ADDENDUM #1 – AUGUST 5, 2025

RE: CHETCO COMMUNITY PUBLIC LIBRARY
Interior Improvements
Project #23.88.1

FROM: HGE ARCHITECTS, Inc.
333 South 4th Street
Coos Bay, Oregon 97420
541-269-1166

Chetco Community Public Library

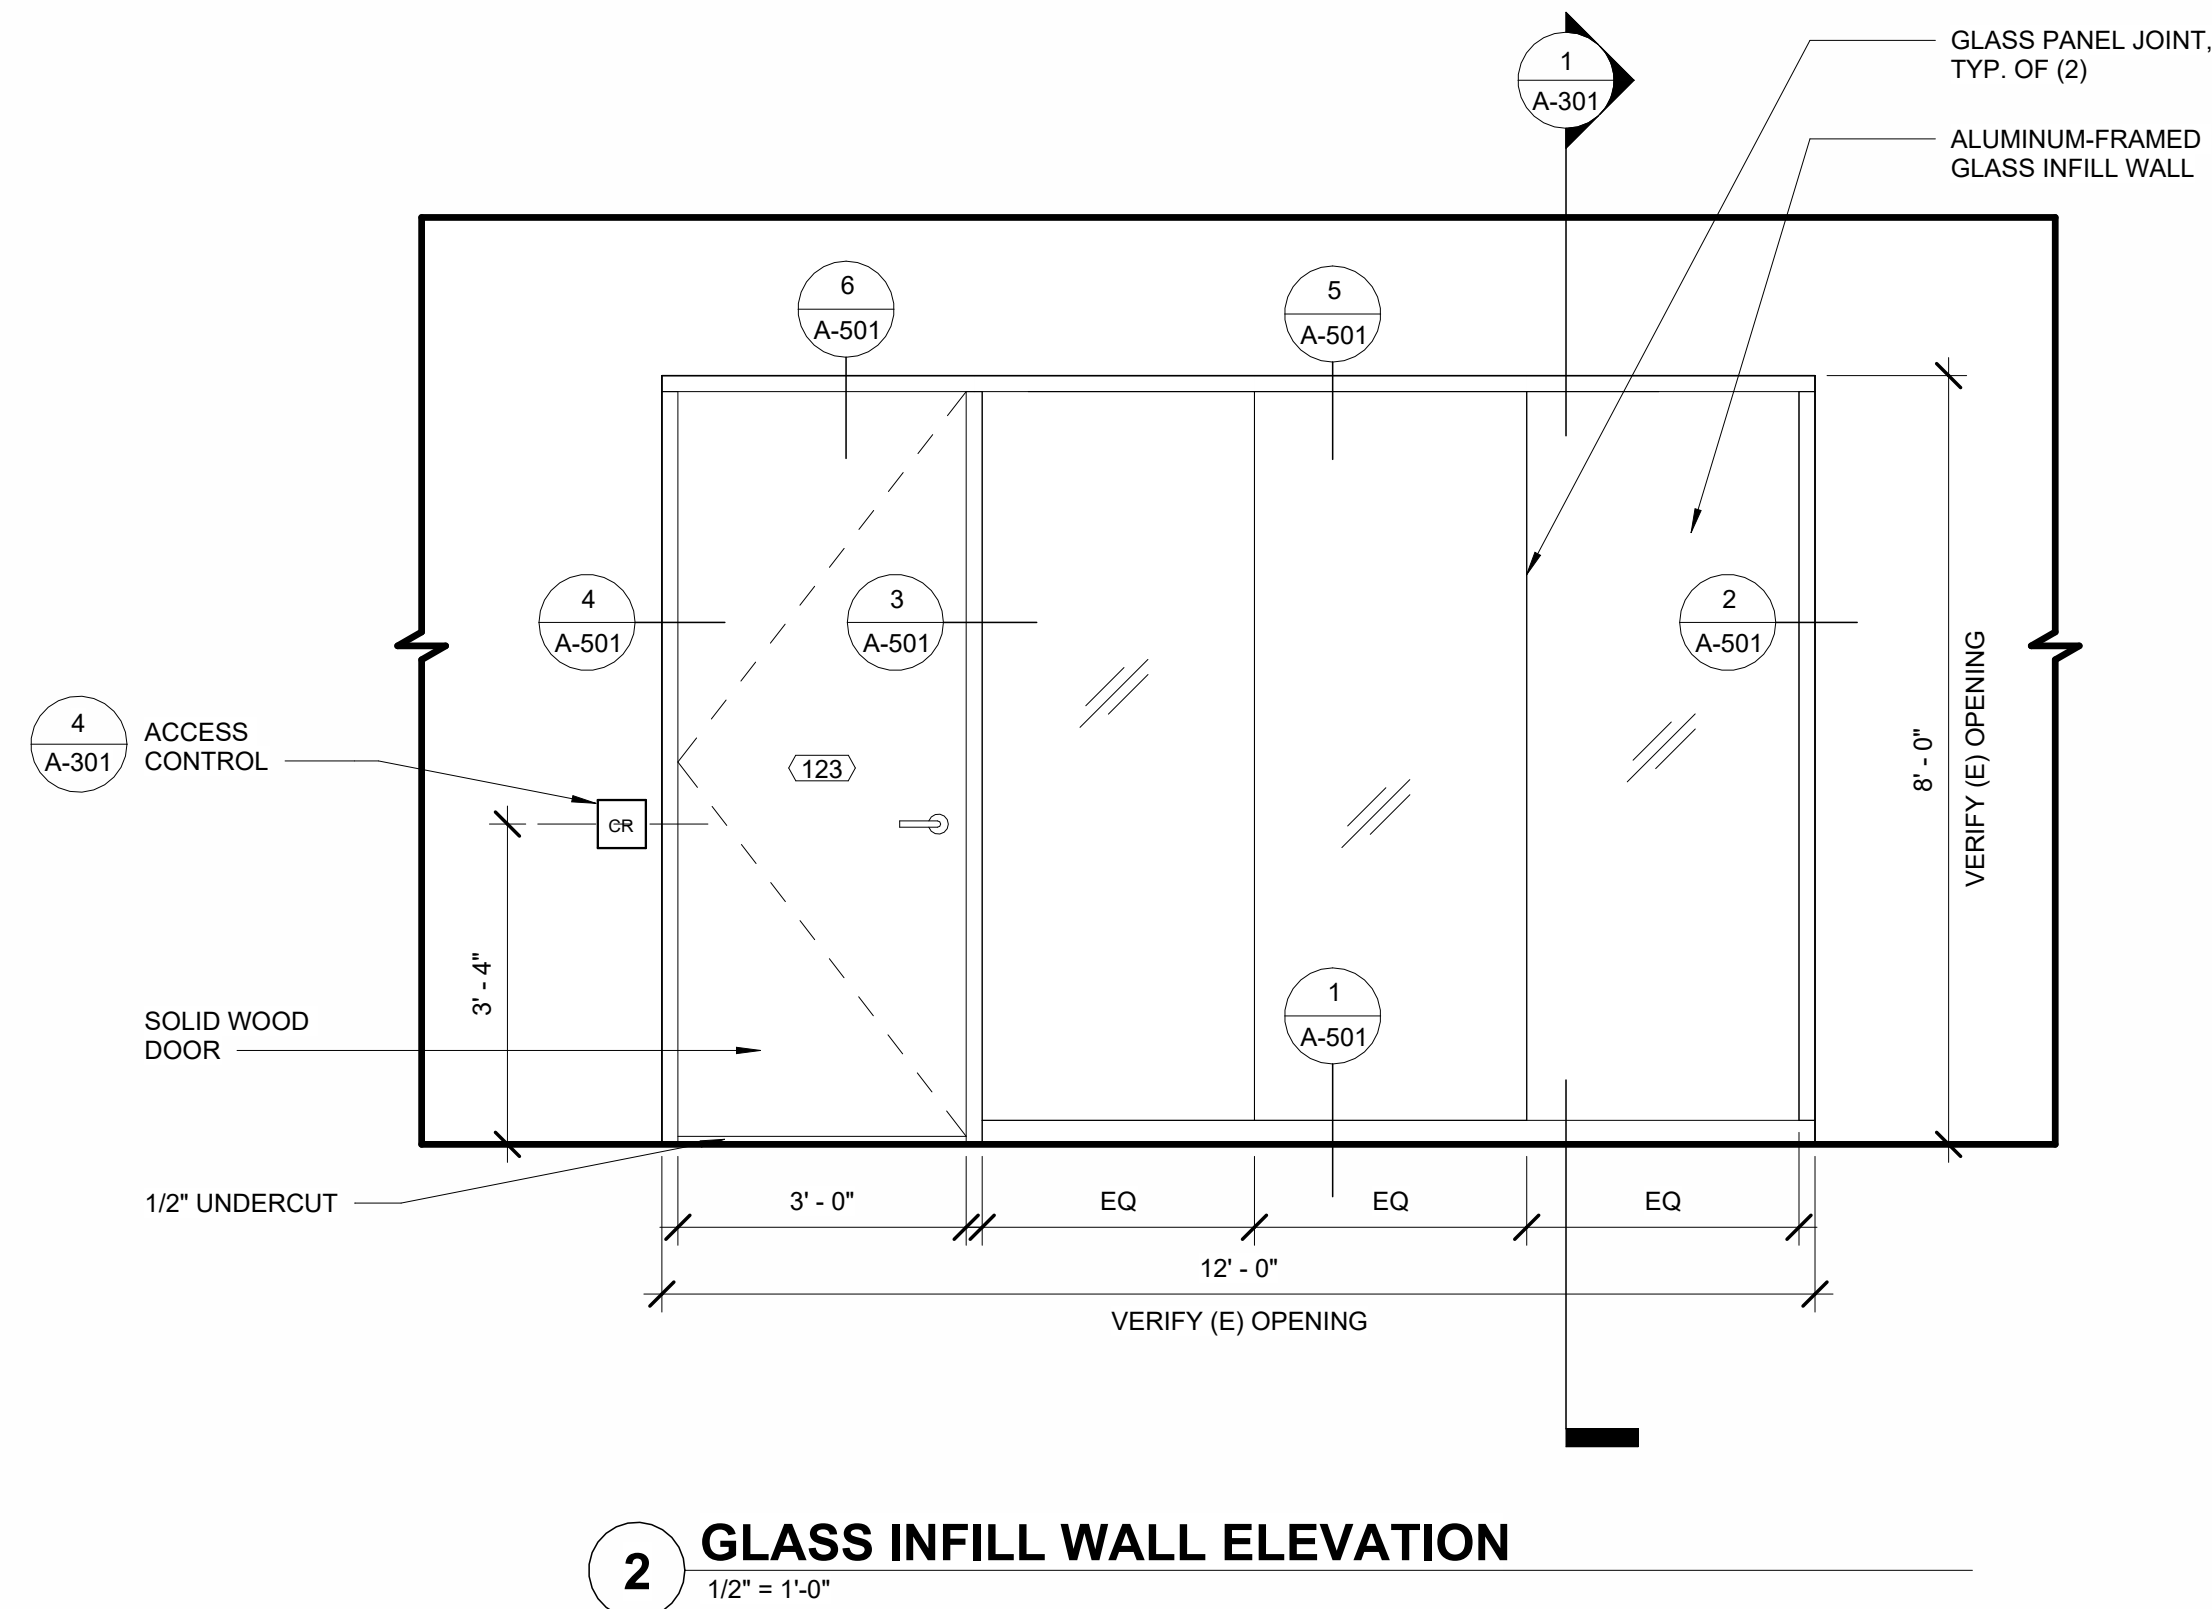
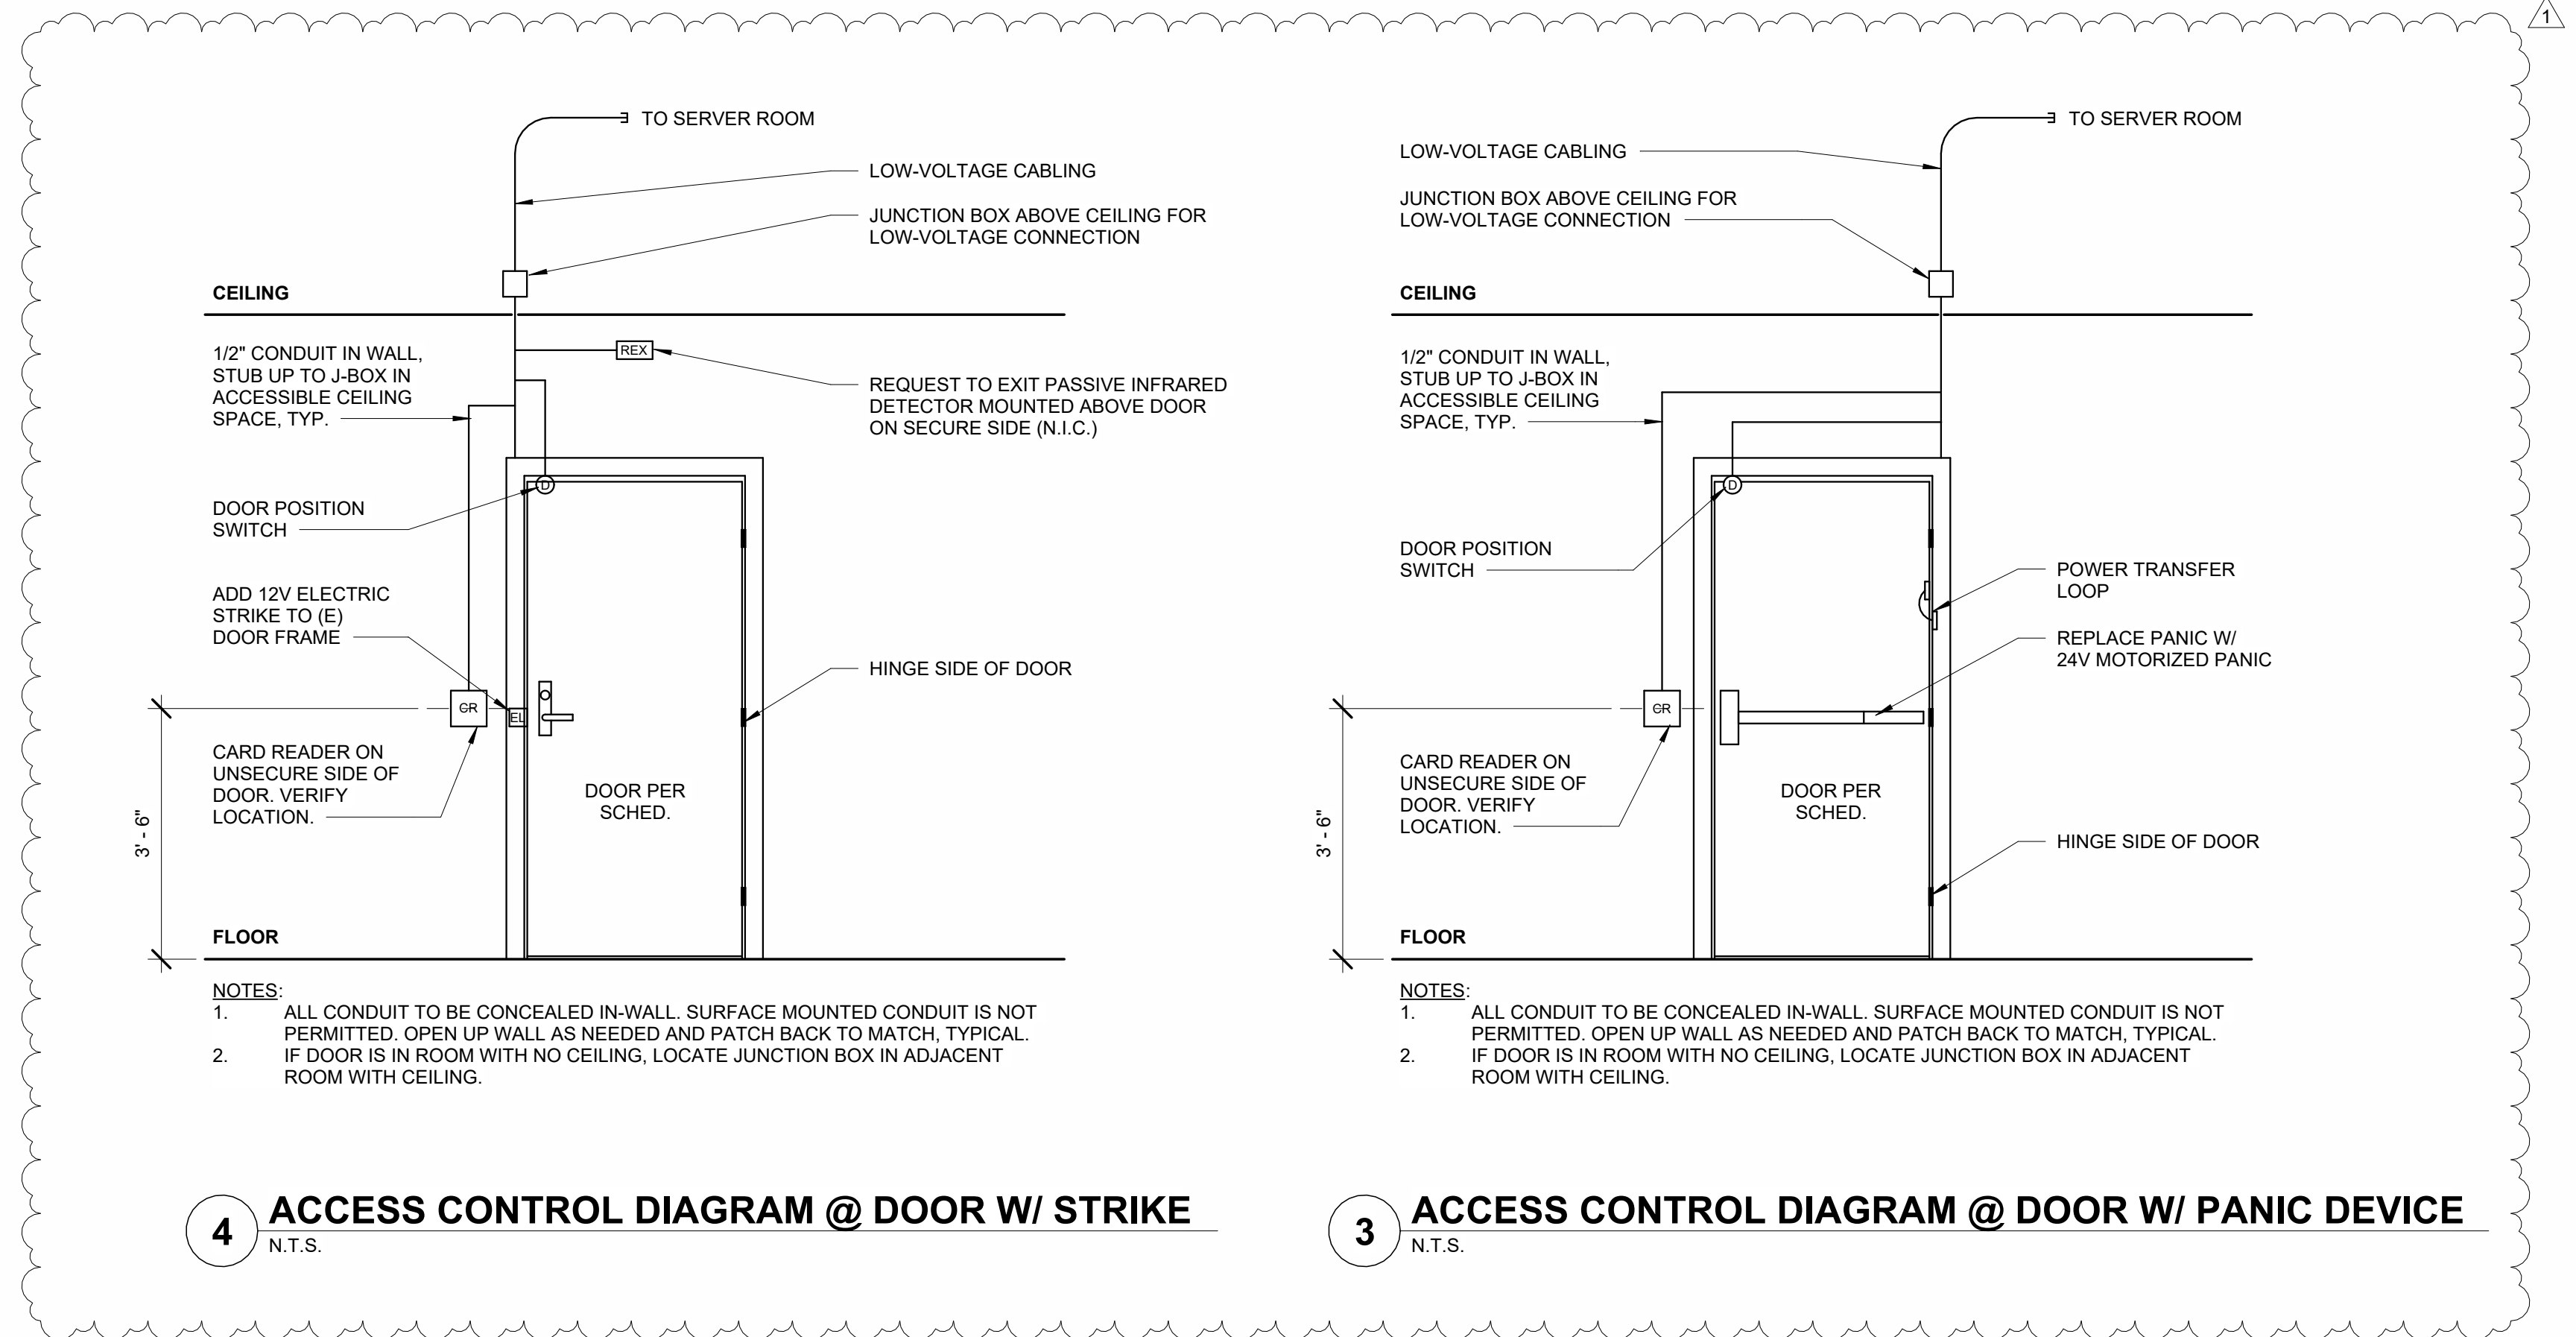
- b. DELETE General Note #3, “Access Control by separate vendor...”
4. **Sheet A-203 Library Reflected Ceiling Plan:** ADD attached Sheet in its entirety.
